Subject: Rafco Property Trust Ltd. rezoning proposal at Howard Avenue and Tuscan Way

RE: File Numbers Z-032/24 [ZNG/7237]

SPC-1.0

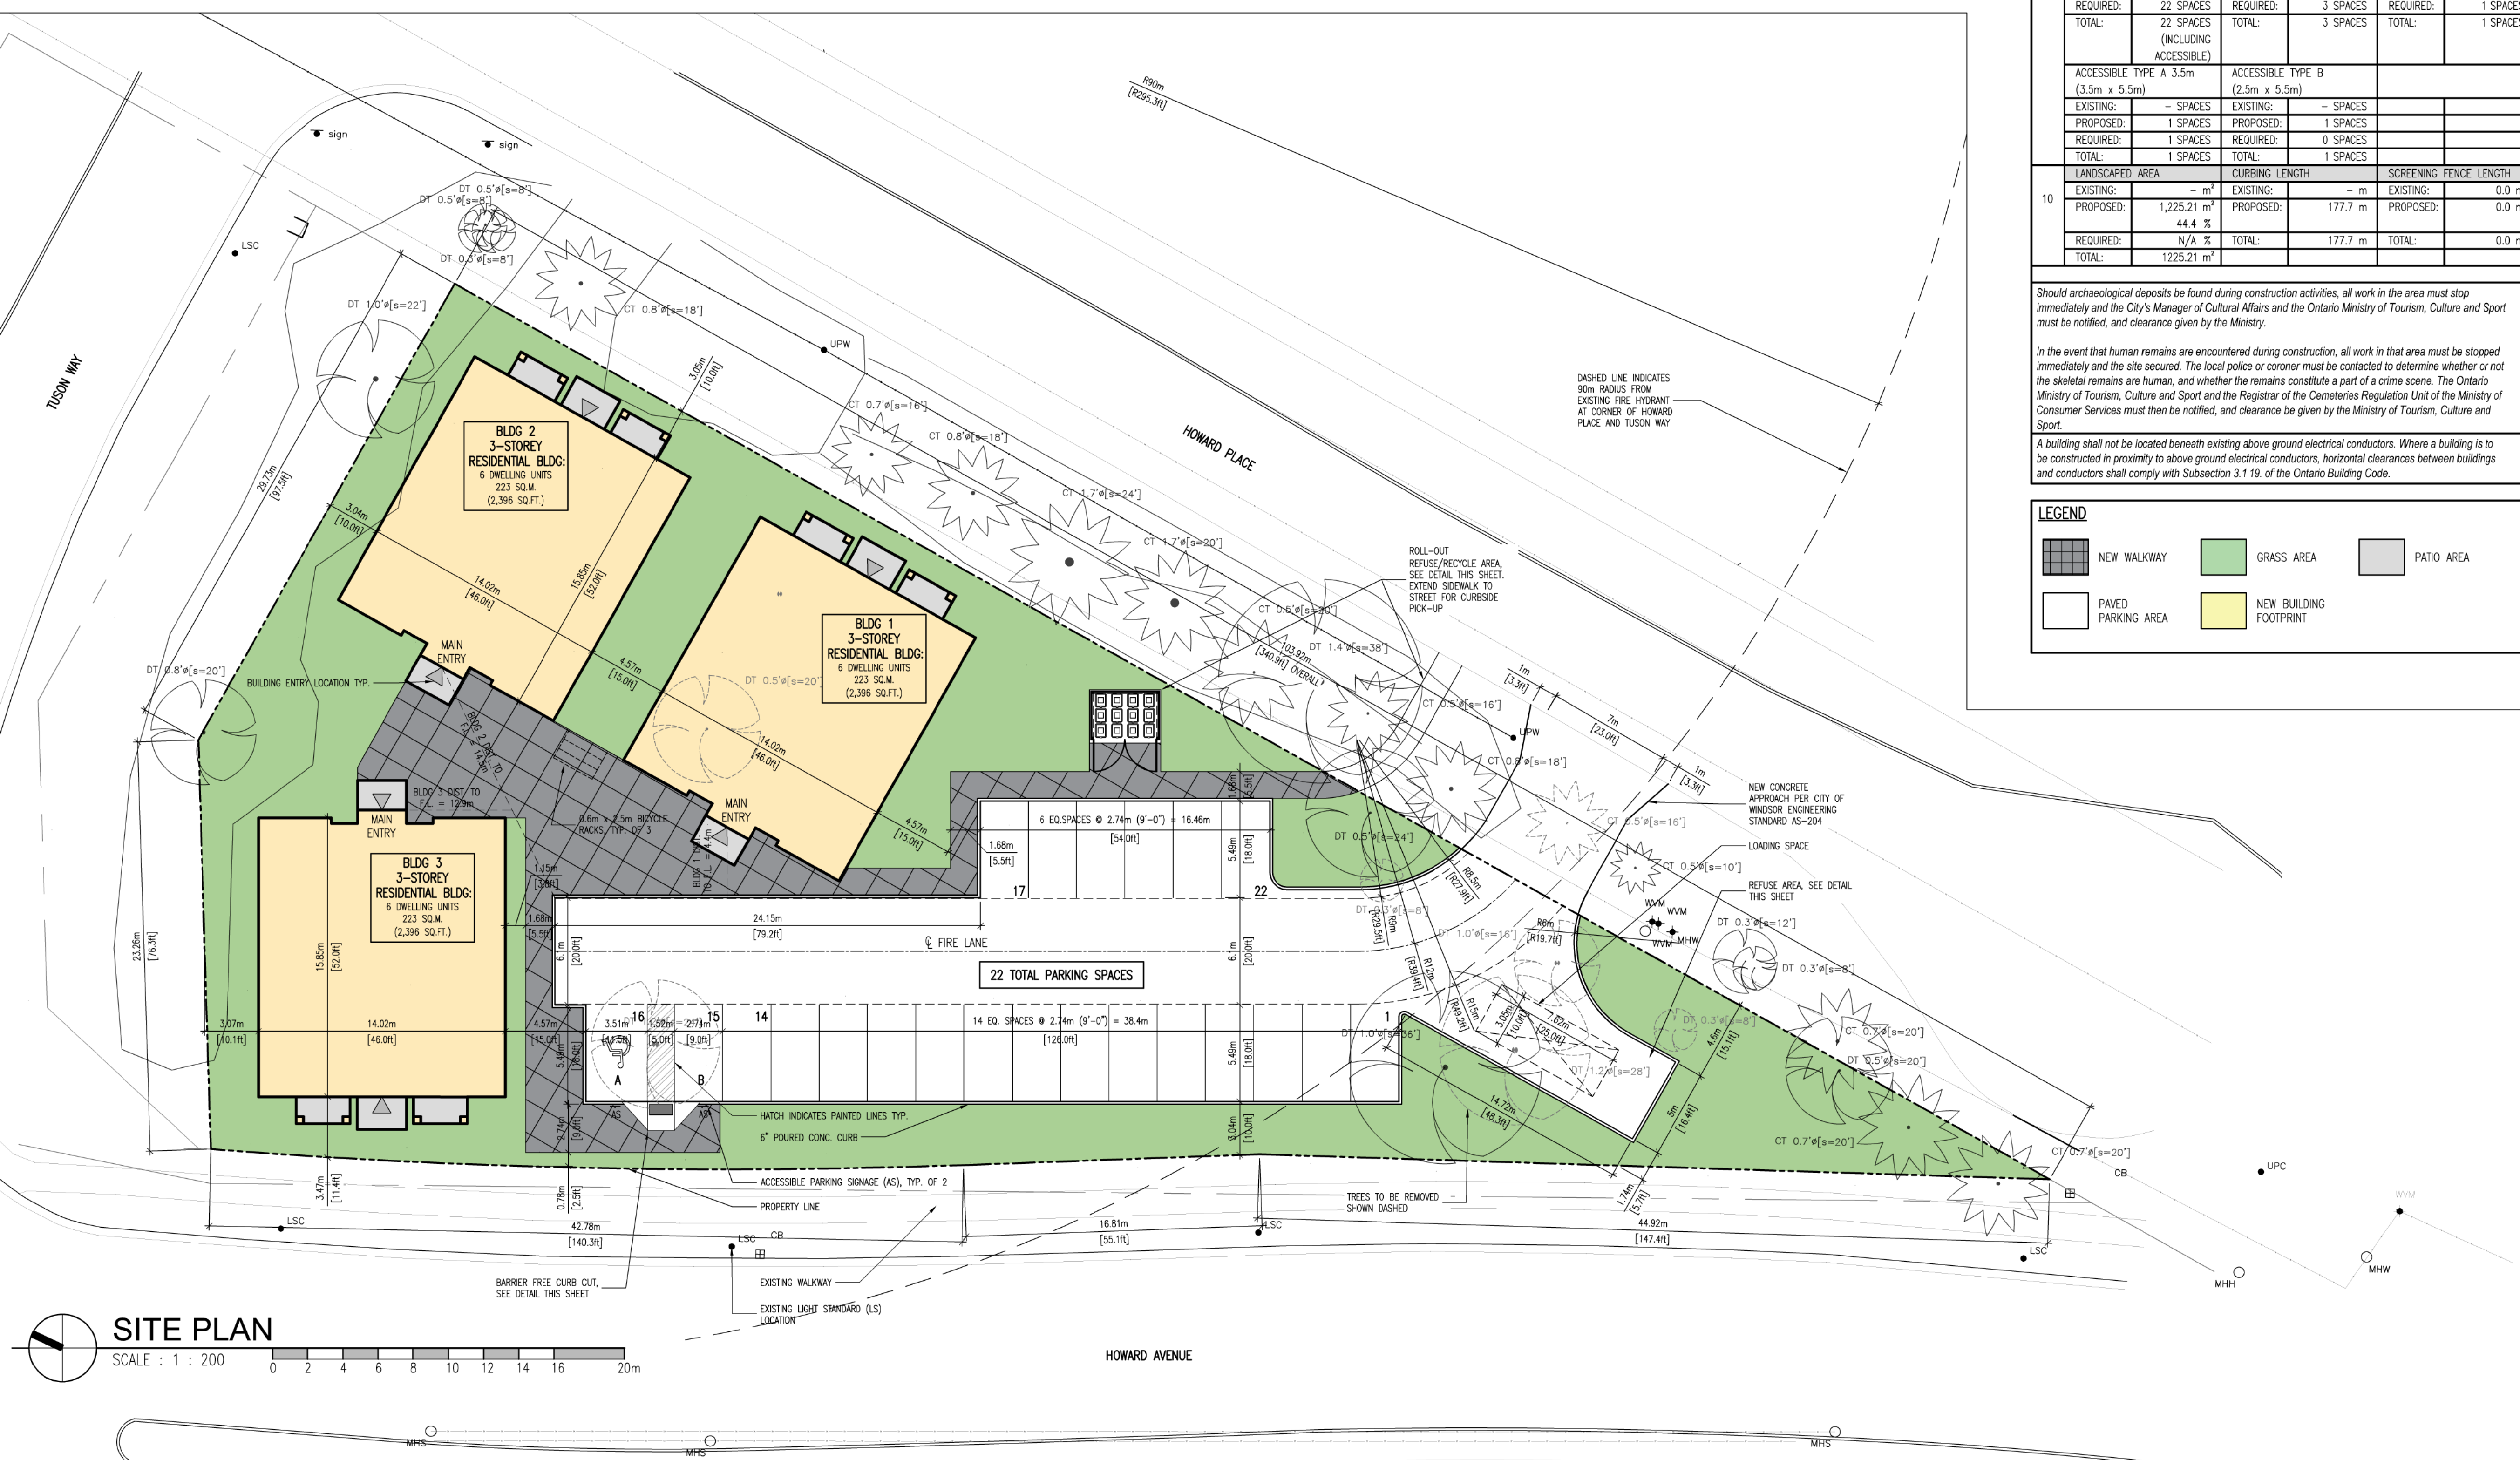
- Tree Inventory & Preservation Study (SPC) – This document was not submitted with the Stage 2 Planning Consultation application. The study must be prepared by a certified Arborist (ISA) or Forester (OFA) to help assess the loss to the urban canopy be submitted with a Site Plan Control application. The study will be used to assess the tree and/or compensation requirements as per consultation with the City Forester.
- Establish a pedestrian connection to the municipal sidewalk on Howard Ave.

Appendix A

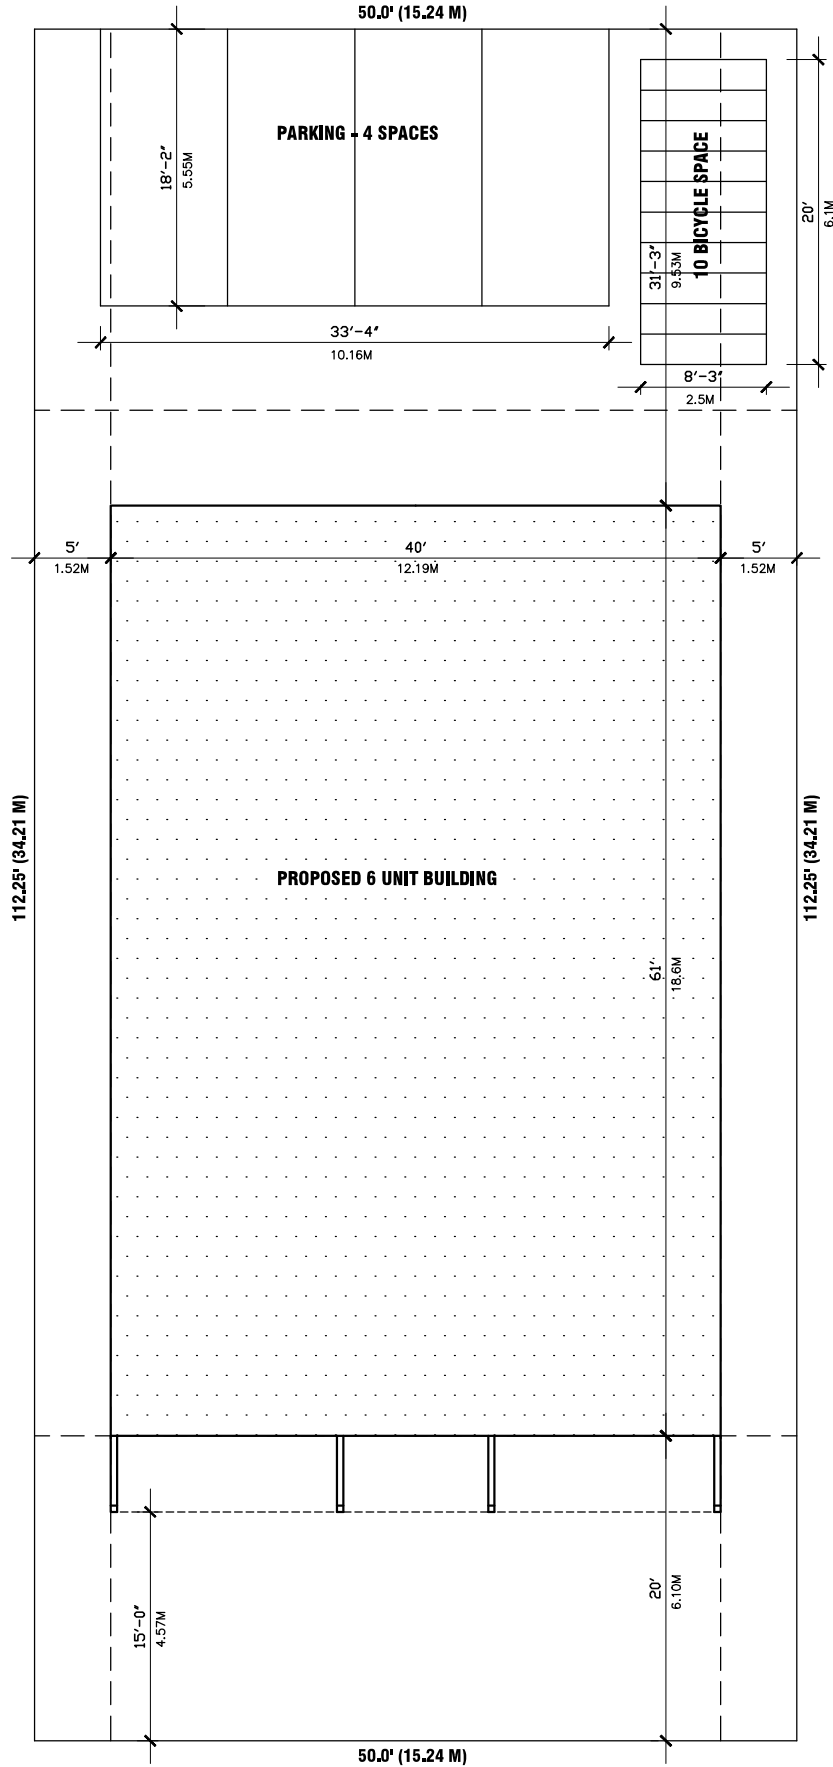
- In the submitted parking study engineers use land use code 217, 1-bedroom unit. This is inappropriate as the proposed development has 2-bedroom units. Furthermore, dense multi-use urban is used, we do not feel this is the most appropriate category for this area. Therefore, we reject the parking study.
- Transportation Planning will not support the overflow from this development to use the on-street parking in the area to meet the minimum requirement, as Janette Avenue's on-street parking is already heavily utilized and under strain. The deficiency in parking for the proposed development will be detrimental to the neighbourhood.
- All accesses shall conform to the TAC Geometric Design Guide for Canadian Roads and the City of Windsor Standard Engineering Drawings.
- All exterior paths of travel must meet the requirements of the Accessibility for Ontarians with Disabilities Act (AODA).
